DATE ~~R~~ Nov.16/01**V2500-A1 SERIES PROPULSION SYSTEM SERVICE BULLETIN**

This document transmits Revision 1 to Service Bulletin EV2500-72-0042

ENGINE - LP COMPRESSOR - REWORK THE LPC FRONT CASING ASSEMBLY TO INCORPORATE AN
ENLARGED PIN HOLE DIAMETER

Location of the LP compressor front case assembly
Figure 1

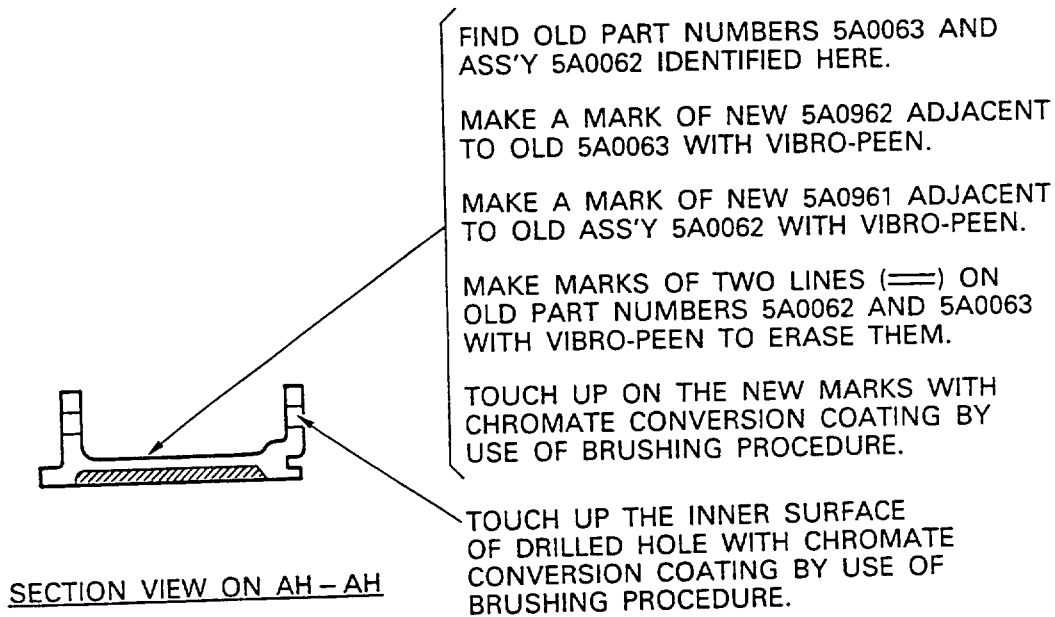
(a) The diameter of the locating pin hole on LPC front case assembly has been enlarged from 0.239 - 0.240 in. (6,07 - 6,10 mm) to 0.252 - 0.259 in. (6,40 - 6,60 mm) (See Figures 1 and 2).

Rework of the LP compressor front case assembly
Figure 2

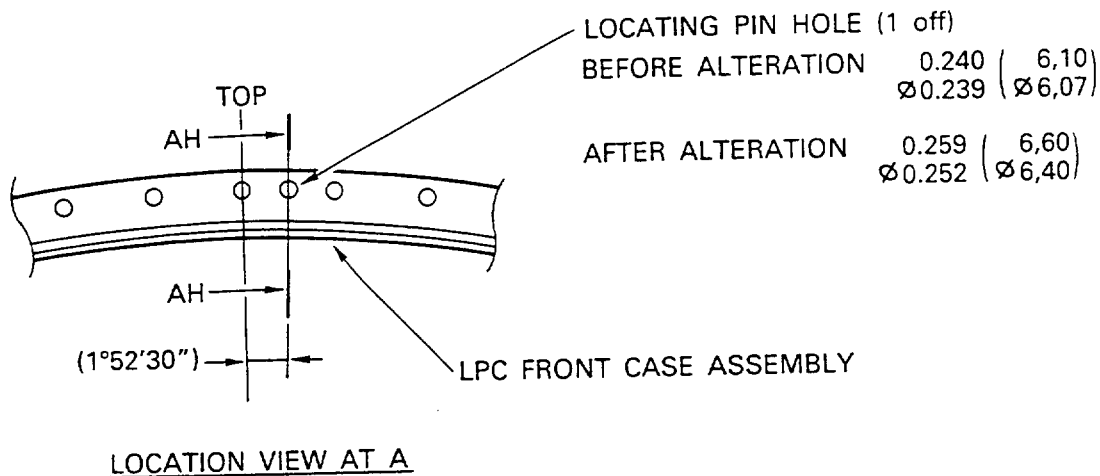
Interference may occur between the locating pin hole on the LPC front case assembly and the locating pin on the LPC rear case assembly depending on the combination of diametral and positional tolerances.

(a) Do an inspection of the LP compressor front case assembly for a diameter of the locating pin hole

(d) Drill the locating pin hole with 0.256in. (6,50 mm) diameter of drill

(e) Remove the burrs from around the hole

(f) Inspect the hole for cracks

(g) Renumber both of the piece part number and the assembly part number identified on the LP compressor front case assembly by use of the vibration peening method

Family tree - LPC front case assembly Ref catalog sequence No. 72-32-83, Fig 01,
Item 350
Fig 3

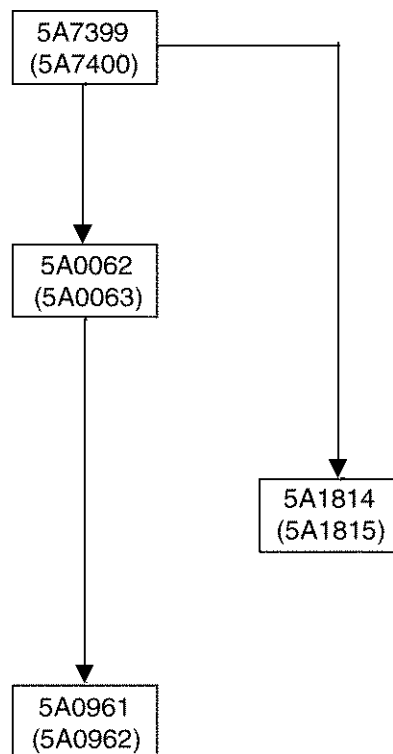
- R (3) For relationship with other Service Bulletins, see 1.K. 'References' and Fig 3 'Family Tree'
- R (4) This Service Bulletin comprises the three parts that follow:
- R Part 1 – Rework of engines incorporating Service Bulletin V2500-ENG-72-0018.
- R NOTE: Refer to paragraph (1) in A. Effectivity to effectivity models.
- R Part 2 – Rework of engines not incorporating Service Bulletin V2500-ENG-72-0018.
- R Part 3 – Re-identification of engines incorporating Service Bulletin V2500-ENG 72-0018
- R NOTE: Refer to paragraph (3) in A. Effectivity to effectivity models
